V2500-A1/A5/D5 PROPULSION SYSTEMS SERVICE BULLETIN

V2500-ENG-80-0015

STARTING – PNEUMATIC STARTER – INTRODUCTION OF A REVISED PNEUMATIC STARTER WITH A
MODIFIED SYNCHRONOUS ENGAGEMENT CLUTCH ASSEMBLY

HAMILTON SUNDSTRAND 80-2515 STARTING - PNEUMATIC STARTER - INSPECTION OF THE SYNCHRONOUS ENGAGEMENT CLUTCH AND REPLACEMENT OF THE WAVE SPRINGS

Figure 1. Output Shaft inspection and Rework

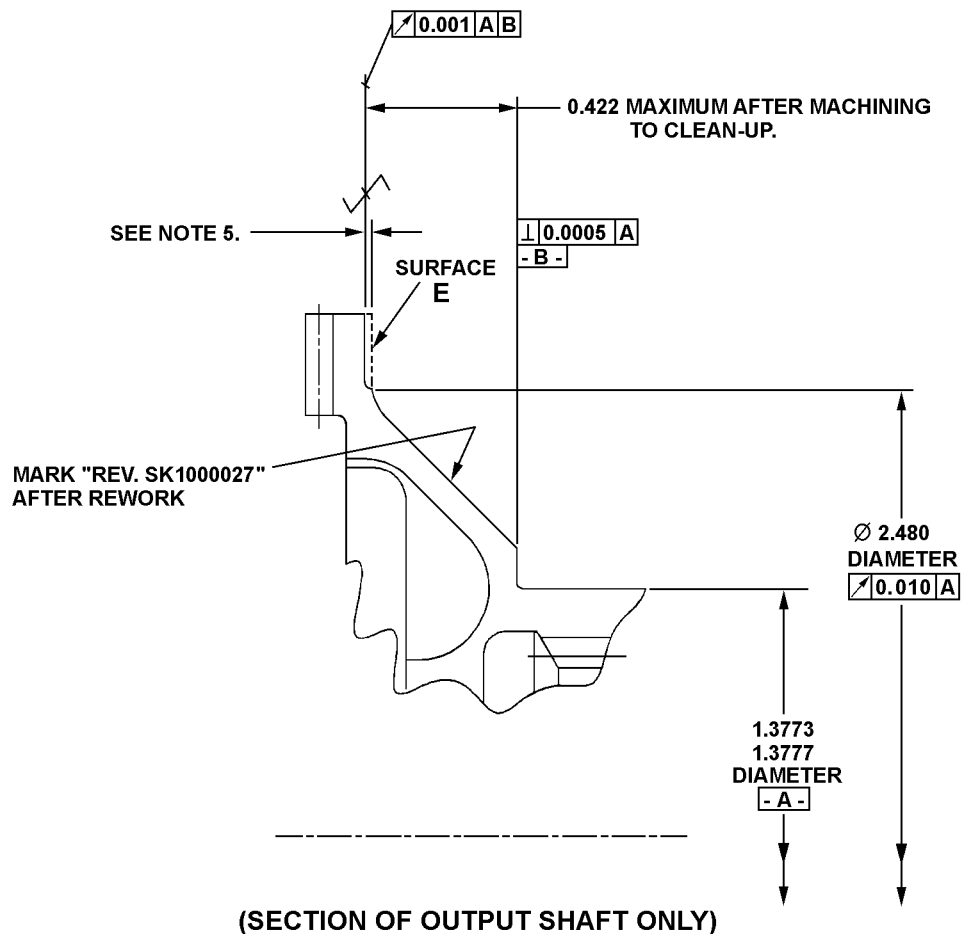
- (6) Inspect output shaft for wear on surface E per **Figure 1**. If worn, machine to clean up within limits shown in **Figure 1**.

NOTE: If the wear can not be removed by machining within the limits shown in figure one the shaft must be replaced.

- (a) If the part is reworked, vibrapreen SK1000027 following PN 813398-1.

Figure 2. Rework and Measurement of Support Carrier

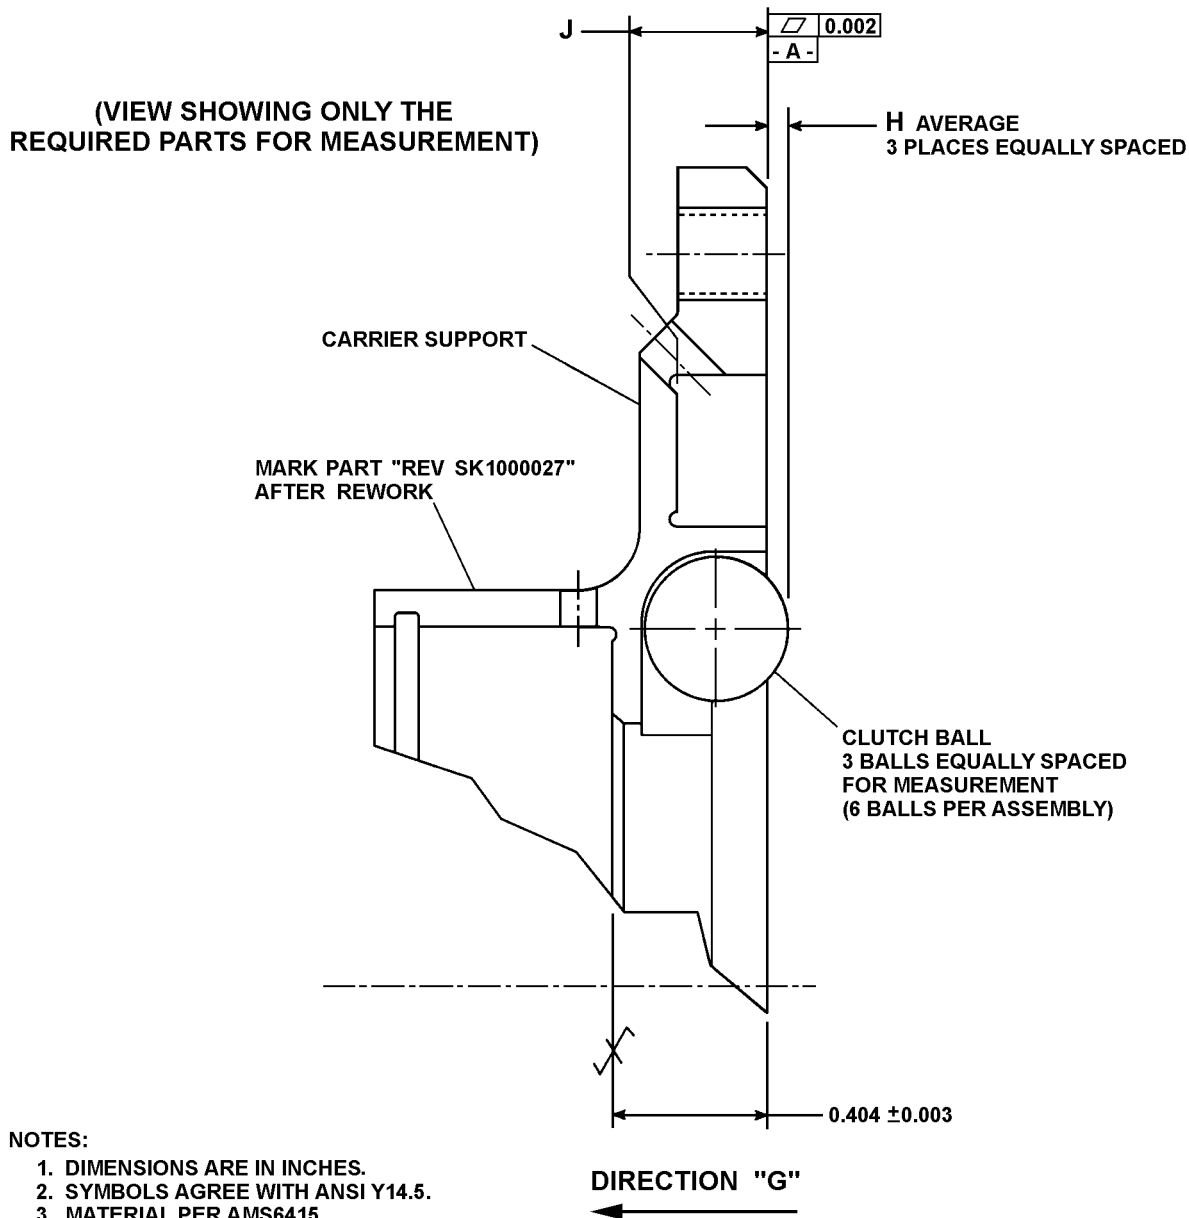
- (7) Rework and Inspect Support Carrier PN 813389-1 as shown in **Figure 2**.
- (a) Rework the wave spring and bearing bore to 0.404 ± 0.003 .
 - (b) Measure dimension H from the top of each of the three balls to surface -A- and record the average result of the three measurements.
 - (c) Measure dimension J from surface -A- to the bottom of the large wave spring bore and record.

Figure 3. Measurement of Dimensions M and N

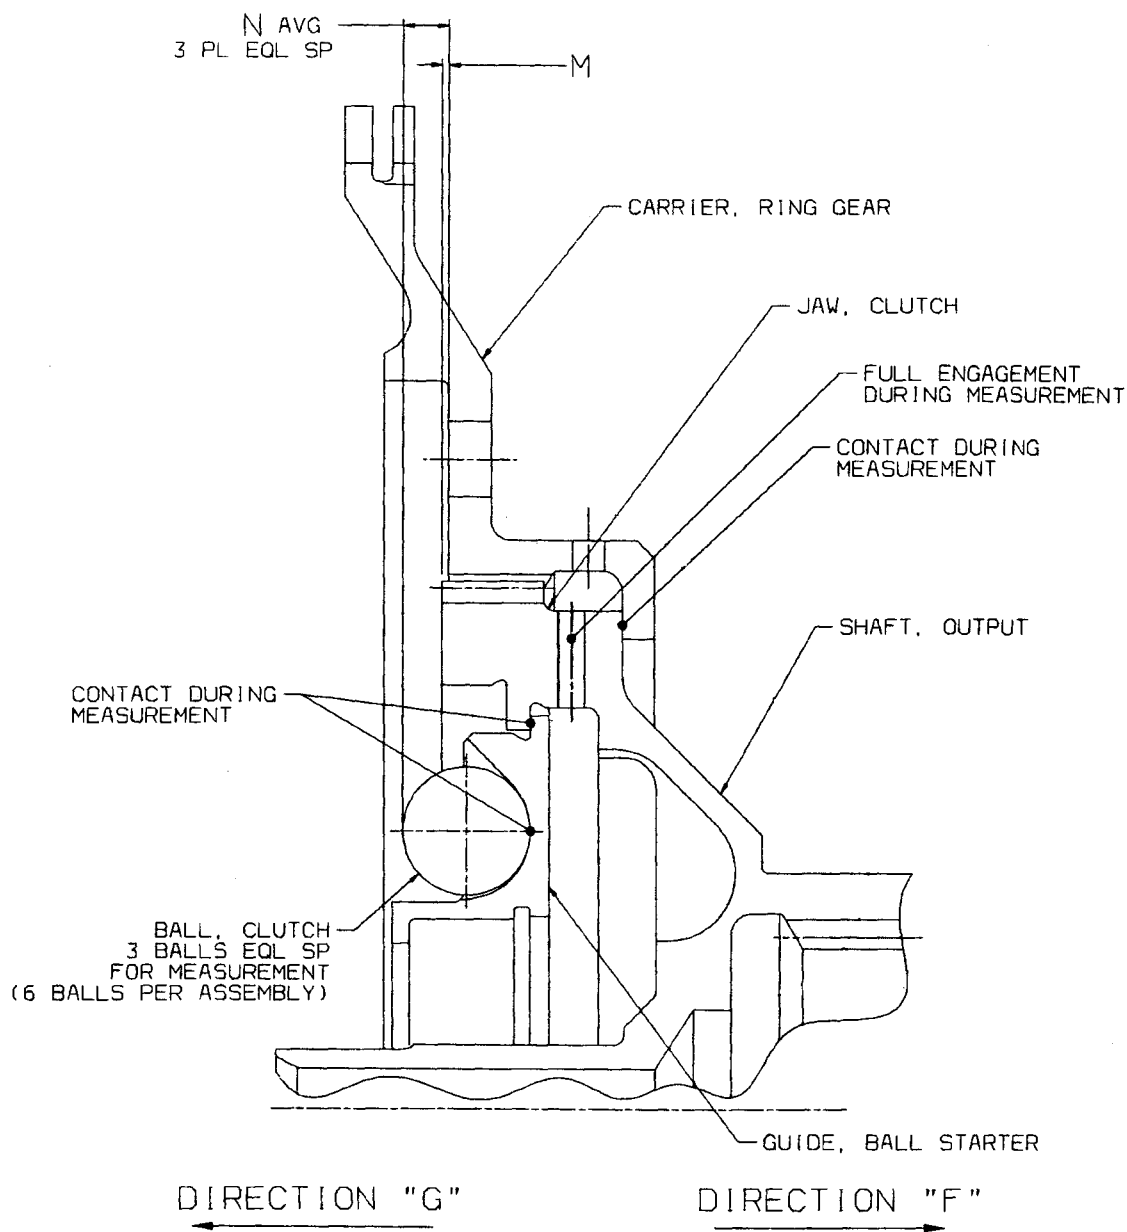
(8) Inspect and record dimensions M and N per **Figure 3**.

- (a) Put the output shaft in ring gear carrier.
- (b) Put clutch jaw PN 813393-1 in ring gear carrier. Load the output shaft and jaw against the ring gear carrier in direction F.
- (c) Measure and record dimension M.
- (d) Take the clutch jaw PN 813393-1 out of the ring gear carrier.
- (e) Put measurement spacer tool PN 63001012 shown in **Figure 10** on the output shaft over the three ball pockets.

- (m) Add dimension H average from step 7 to dimension N average. If the sum of H plus N is equal to or greater than 0.185 inch, proceed with the following steps. If it is less than 0.185 inch, the clutch assembly must be replaced.

Figure 4. Marking the SK Inspected and Reworked Parts

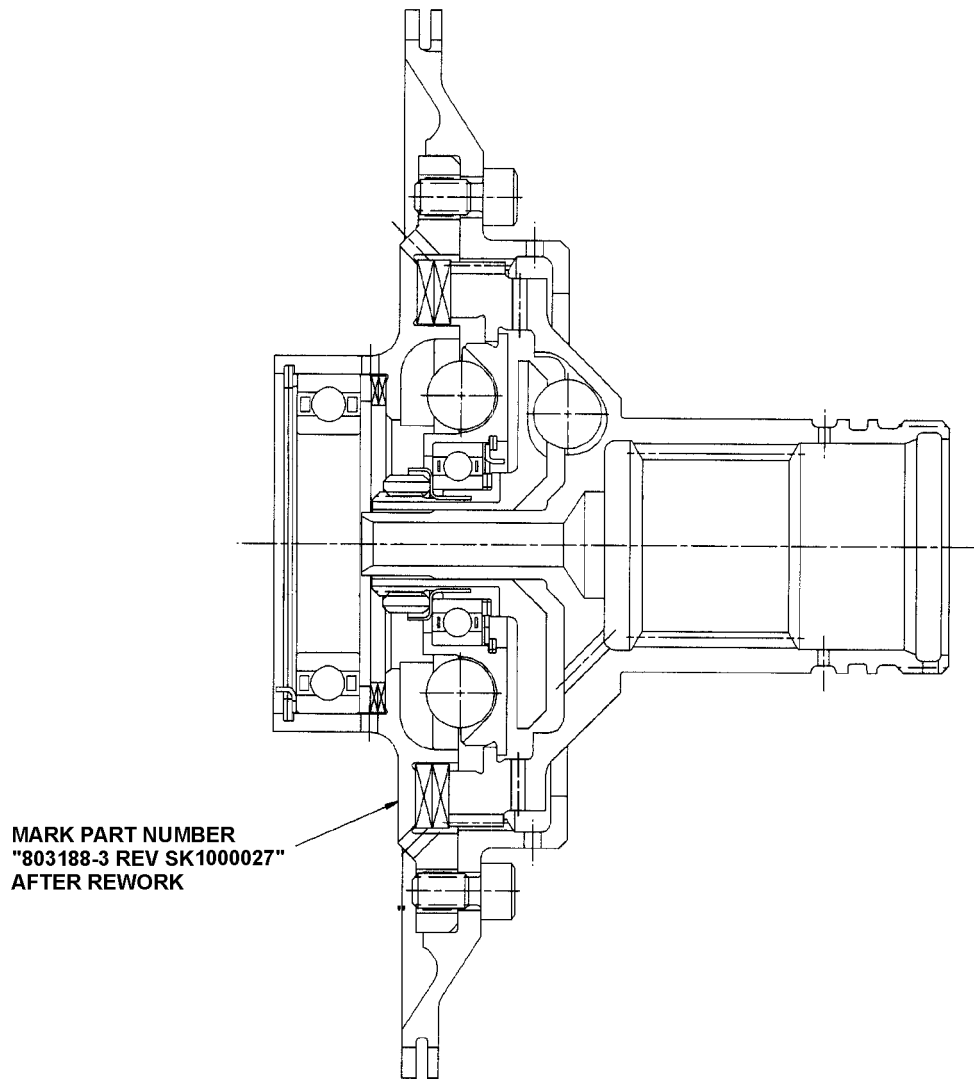
- B. If dimensional condition in step 3.A.8.(m) is acceptable and the parts were not previous marked during the inspection process, mark the clutch parts as follows using any shallow method impression marking of less than .003 inches. This includes electrolytic etching and vibrapeen:
- (1) Mark the support carrier with “(Rev. SK1000027)” following the existing part number 813389-1.
 - (2) Mark the output shaft with “(Rev. SK1000027)” following the existing part number 813398-1.
 - (3) Mark the inspected and reworked clutch assembly part number “803188-1” as follows:
 - (a) Using vibrapeen put “PN 803188-3 (Rev. SK1000027)” on the carrier support as shown in **Figure 4**.

NOTE: The clutch assembly part number, “PN 803188-1” will not be marked on the clutch assembly that you removed from the starter. You are adding it to identify that the part was reworked to this service bulletin. It is very important to include “Rev. SK1000027” in the part identification. This is part of the part number for a reworked clutch.

Figure 5. Ring Spacer Selection

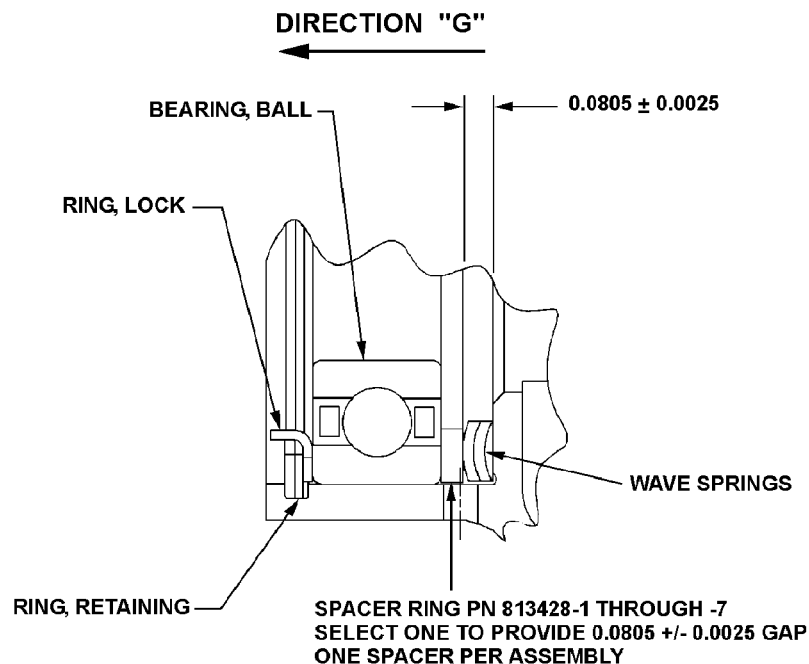
- (a) Install spacer ring, bearing, and lock ring and retaining ring in carrier support as shown in **Figure 5**.
- NOTE:** Do not bend lock ring at this time.

- NOTE:** Do not install wave springs.
- (b) Load spacer ring, bearing, and lock ring and retaining ring DIRECTION "G".
 - (c) Measure the gap for the wave spring and select Spacer Ring PN 813428-1 through -7 to obtain a gap of .0805 +/- .0025 inches.

Figure 6. Jaw Shimming

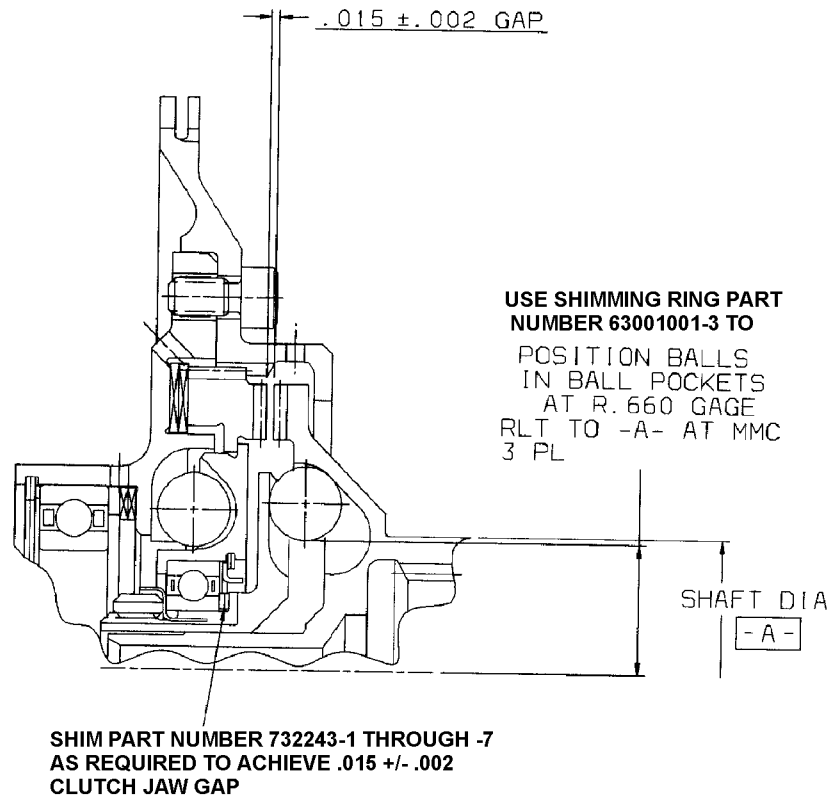
- (2) Assemble the clutch using the CMM assembly procedure except shim the clutch jaw as follows:
- (a) Use the instructions in the CMM Assembly section to assemble the clutch except shim the clutch jaw gap to 0.015 ± 0.002 inch as shown in **Figure 6** and install the new wave springs part number 1000663-1 (2 required) and PN 1000664-1 (2 required) as shown in **Figure 7**.
